**CITY OF WINFIELD
PUTNAM COUNTY, WEST VIRGINIA**

CONTRACT NO. 1 – WASTEWATER TREATMENT PLANT IMPROVEMENTS

ADDENDUM NO. 4

S8

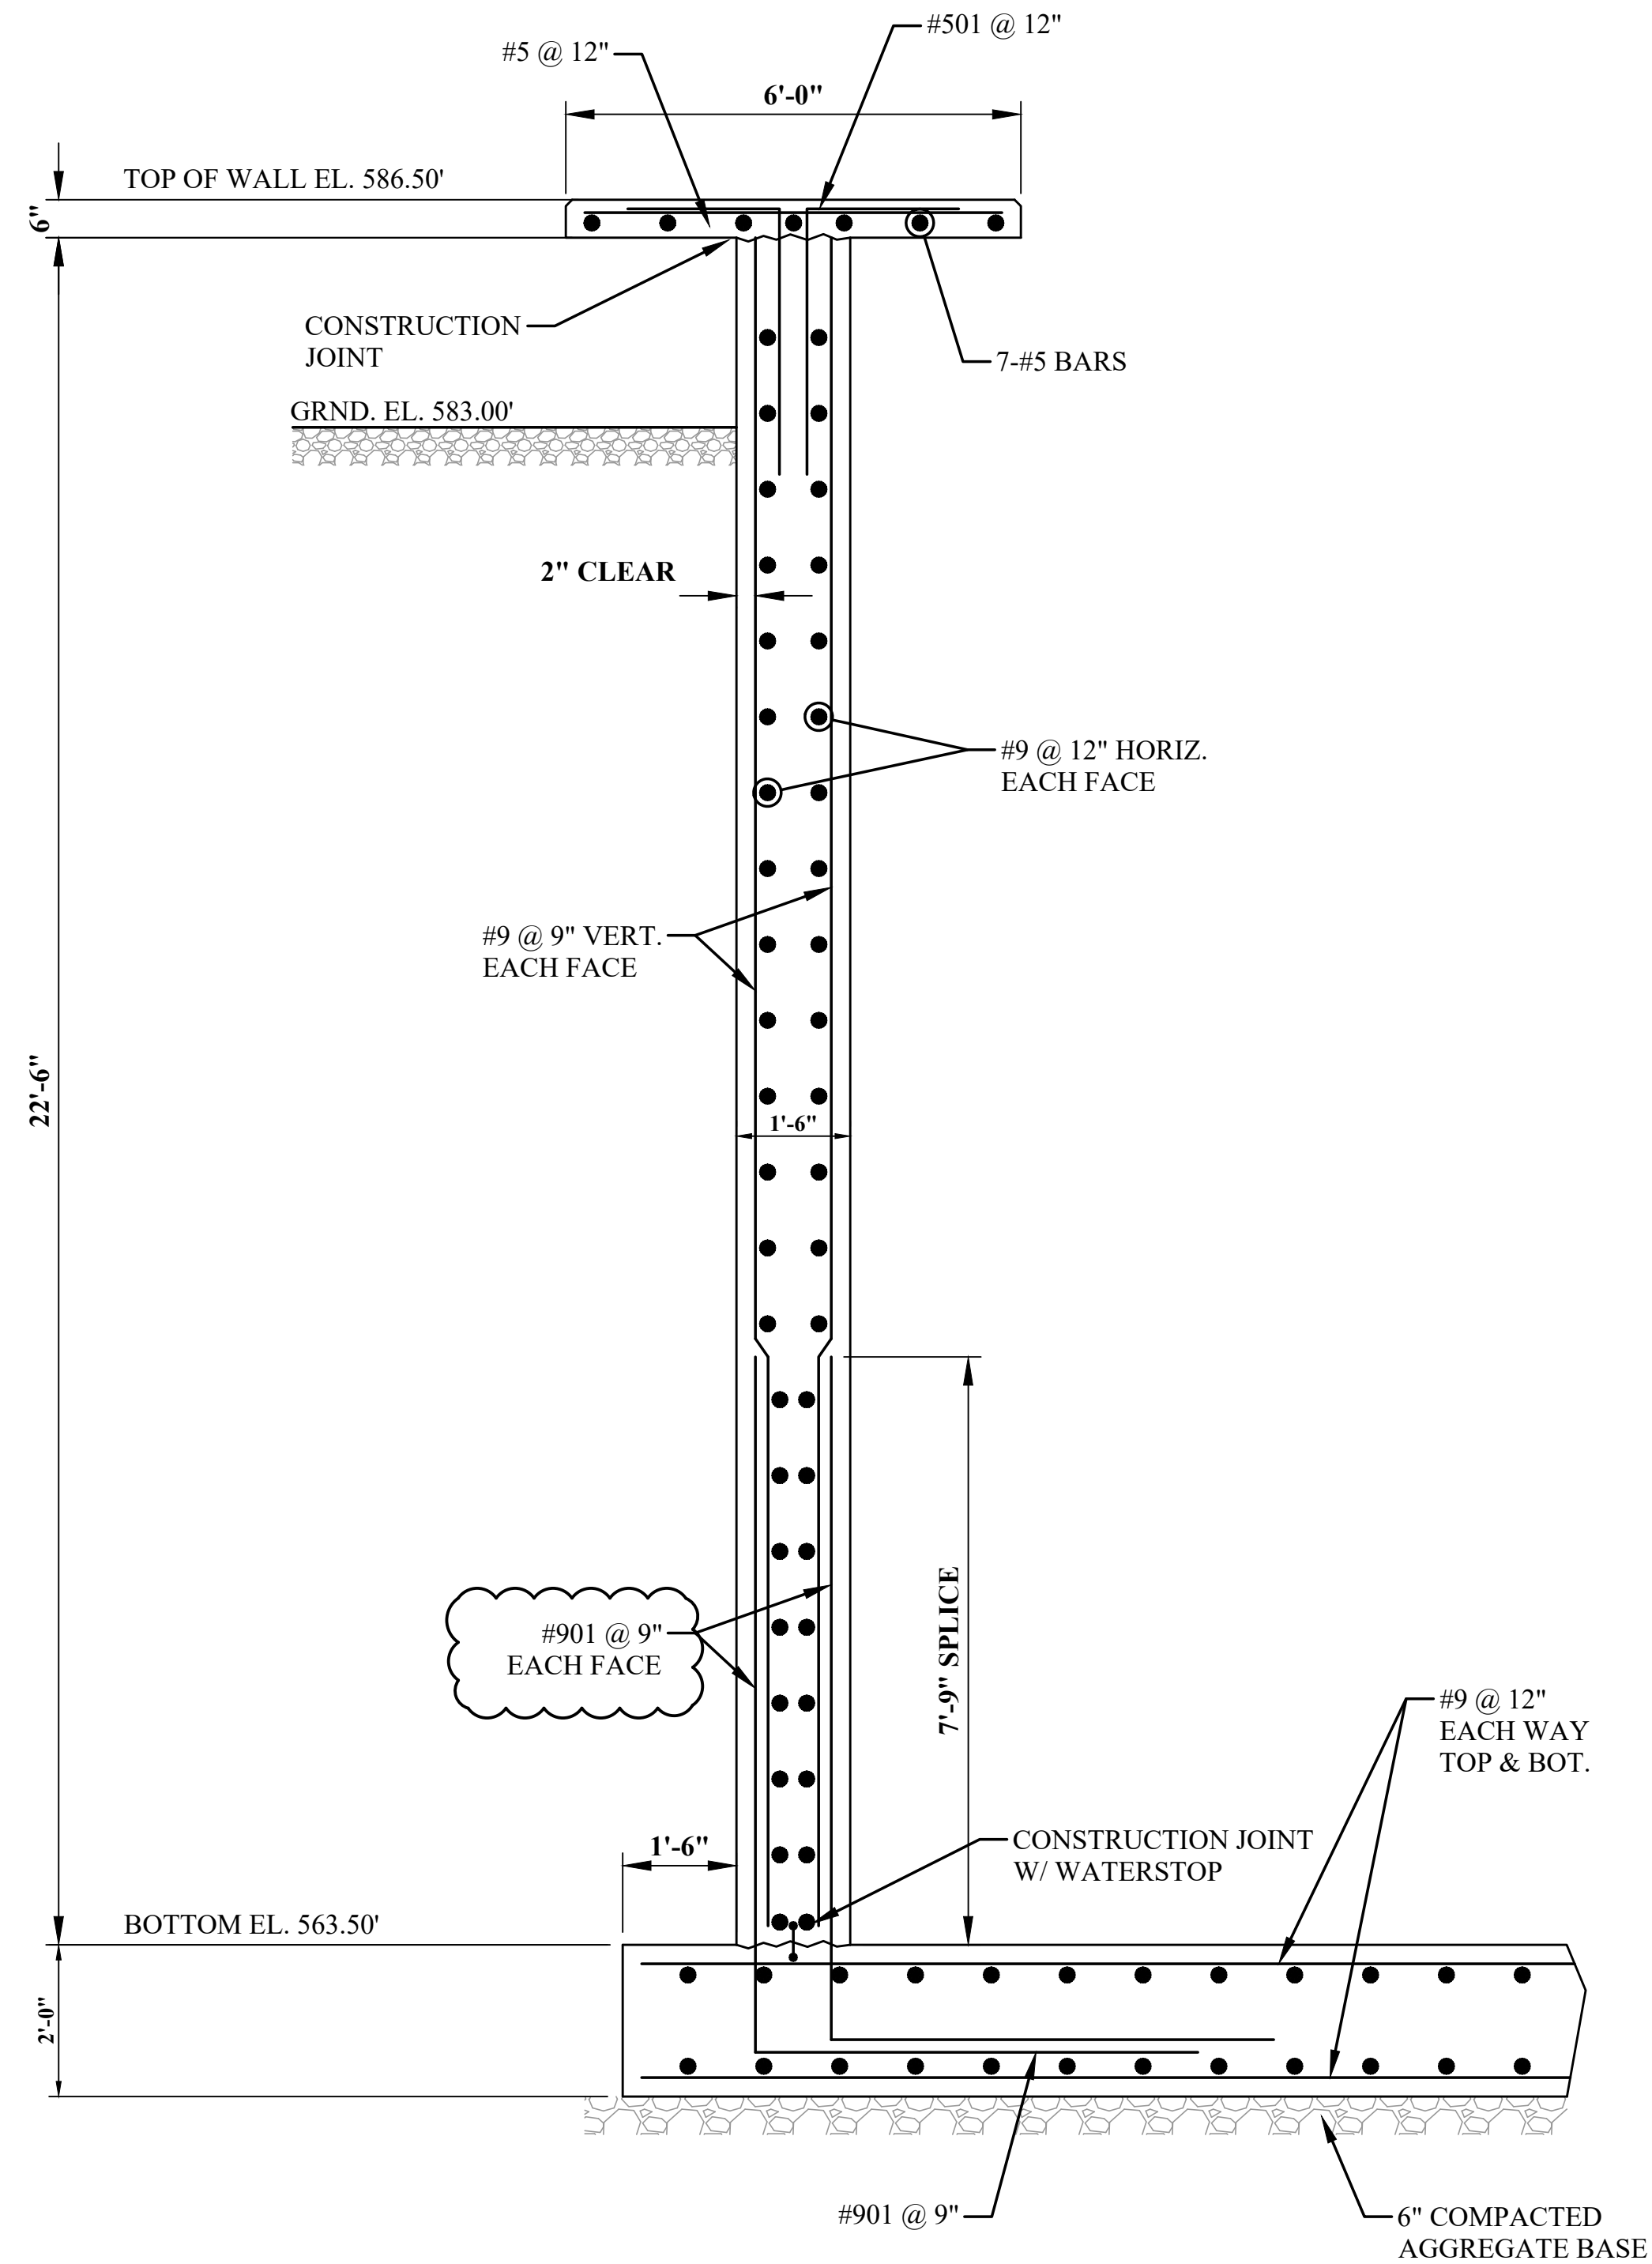
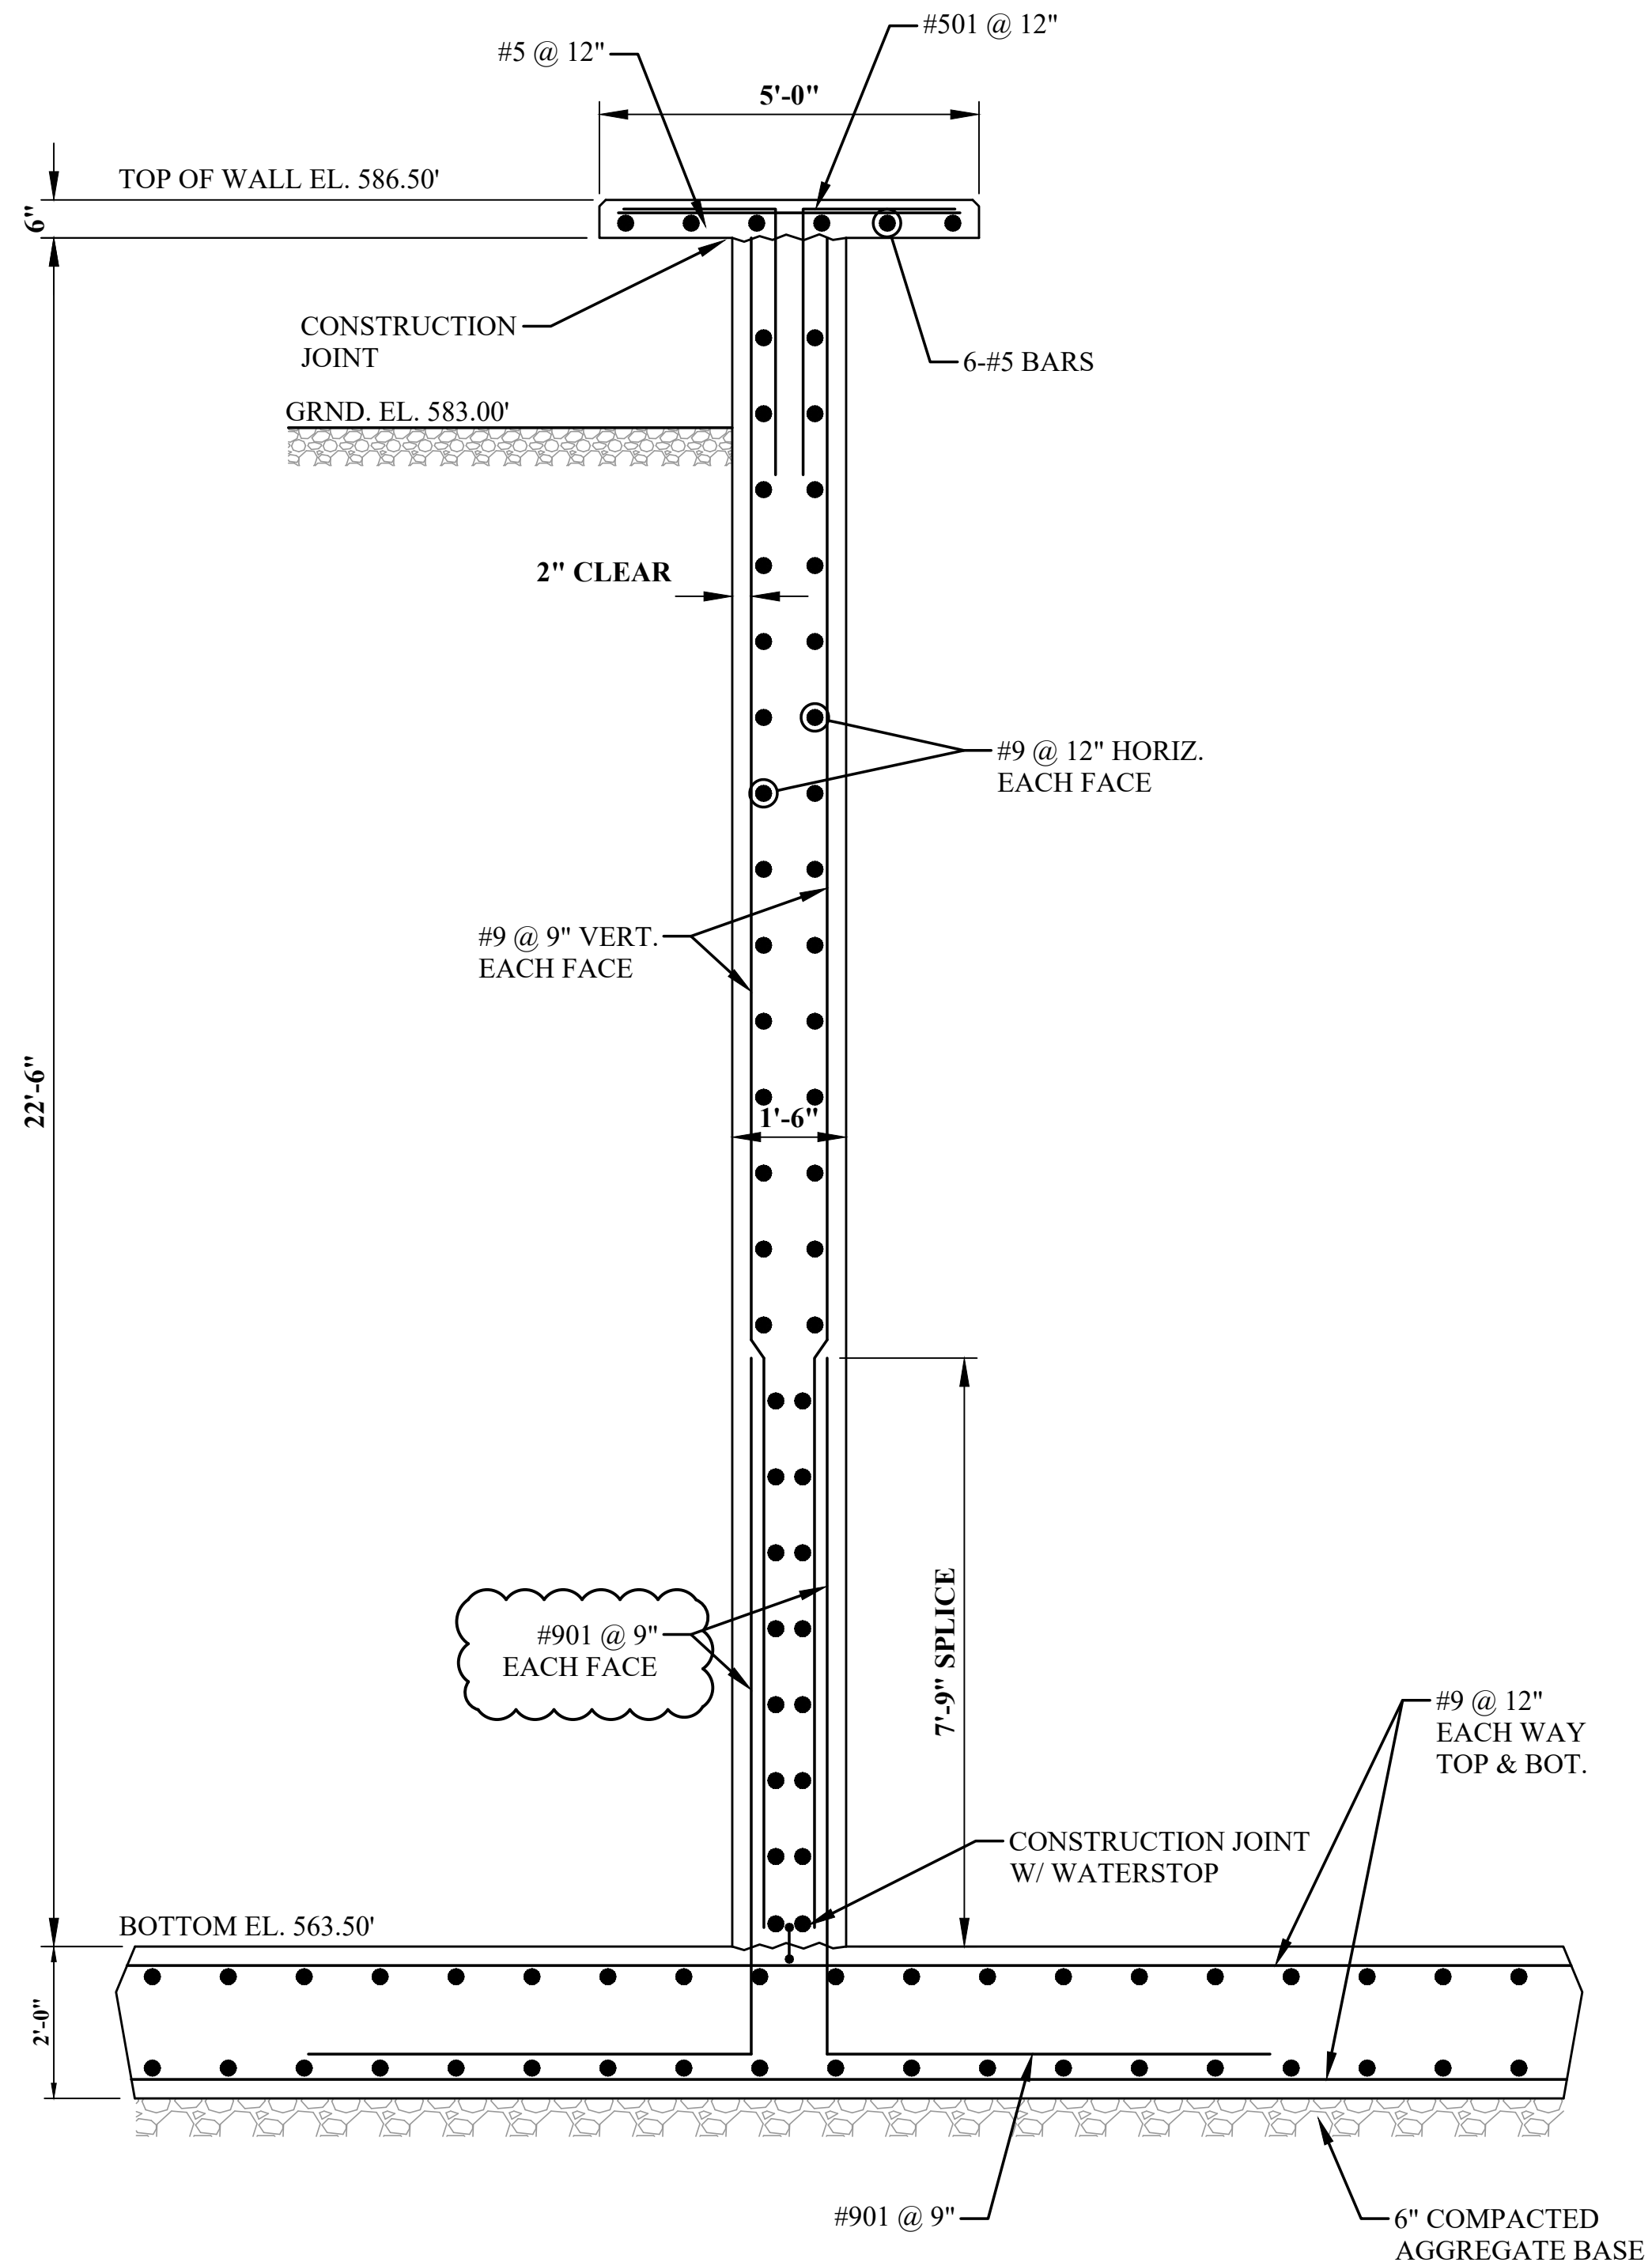
1. **DELETE** Sheet S8 in its entirety and **REPLACE** with the attached Sheet S8.

6. **Question:** Please clarify. Are the #9 dowels #901 in the SBR tank shown on Sheet S8 at 9” centers or at 6” centers? They are labeled both ways at Sections A/S2 & B/S2 at Sheet 8.

Answer: The vertical #9 dowels are on 9” centers, the horizontal #9 dowels are on 12” center, and the #901 dowels are on 9” centers. See revised Plan Sheet S8 attached to this addendum.
